**ALERT SERVICE BULLETIN**

NO. 427-08-20  
DATE Feb 27, 2008  
PAGE 1 of 5

**MODEL AFFECTED:** 427

**SUBJECT:** COLLECTIVE CONTROL IDLER LINK ASSEMBLY P/N 427-001-532-101 INSPECTION AND MODIFICATION OF

Figure 1

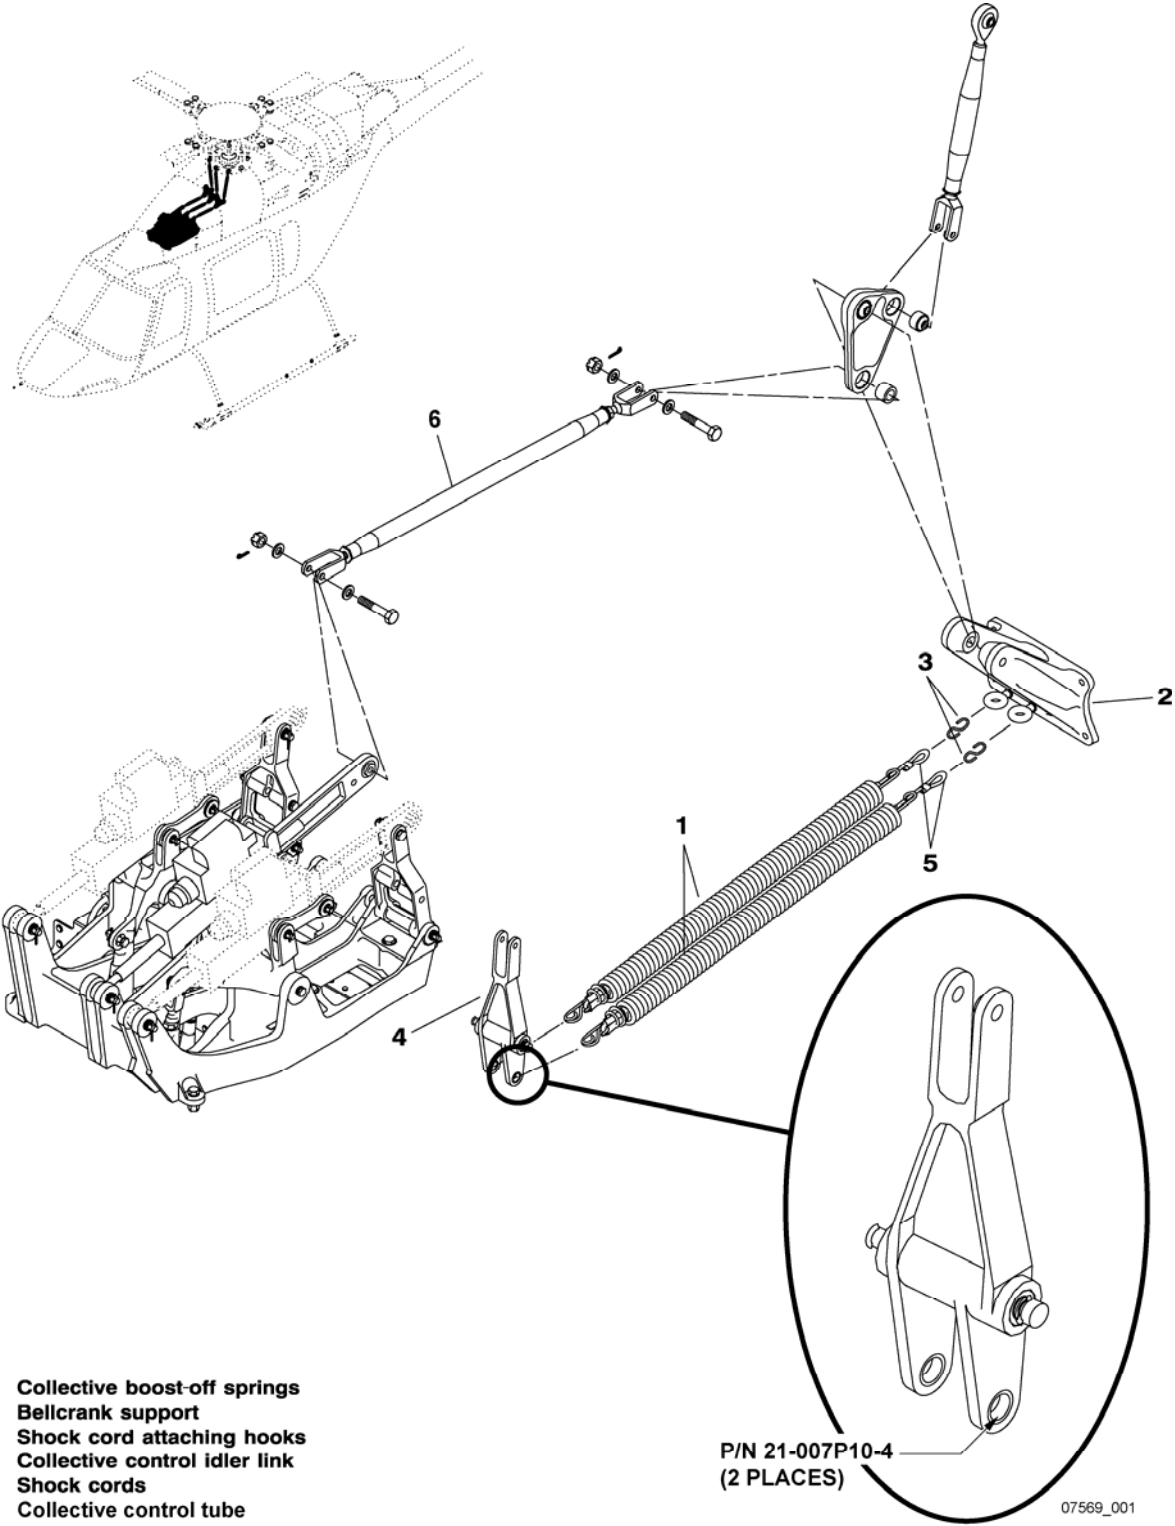
Bell Helicopter has received reports of worn bushings P/N 21-007P10-4 installed in the collective control idler link P/N 427-001-532-101. The bushings are used as the attachment pivot point for the two collective boost-off springs.

This bulletin provides instructions for the replacement of the two bushings P/N 21-007P10-4 and installation of new bushings P/N 21-007K10-4 made from Chromium Steel.

8. Inspect idler link for condition. Replace the two existing bushing P/N 21-007P10-4 in the collective control idler link P/N 427-001-532-101 with new bushing P/N 21-007K10-4. Apply MIL-PRF-23377 epoxy primer to outside diameter of the new bushing. Refer to the BHT-ALL-SPM, chapter 9 for bushing installation.

9. Re-identify the modified collective control idler link with P/N 427-001-532-105.
10. Install the collective control idler link with P/N 427-001-532-105. Refer to the BHT-427-MM, chapter 67.
